**Resource Consent Application RM240001, Tahua Properties Limited – Request for Further Information (s92 RMA)**

Following a review of your application for the proposed restaurant activities at 69A Main Road, Tirau, we request the further information as outlined below to assist in assessing the potential environmental effects of the activity:

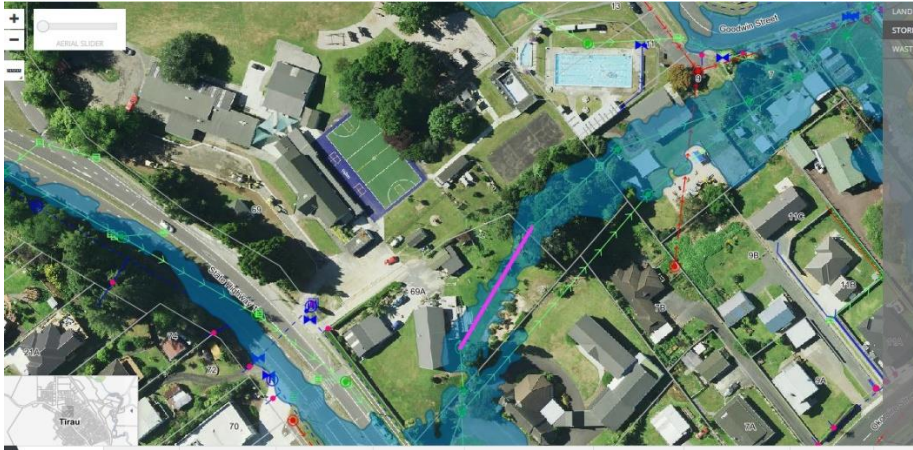
a) Section 4.4 of the application indicates that the proposed activities are able to comply with the District Plan noise requirements however Section 5.1 indicates that the activities are unable to comply. Please advise if compliance is achieved.
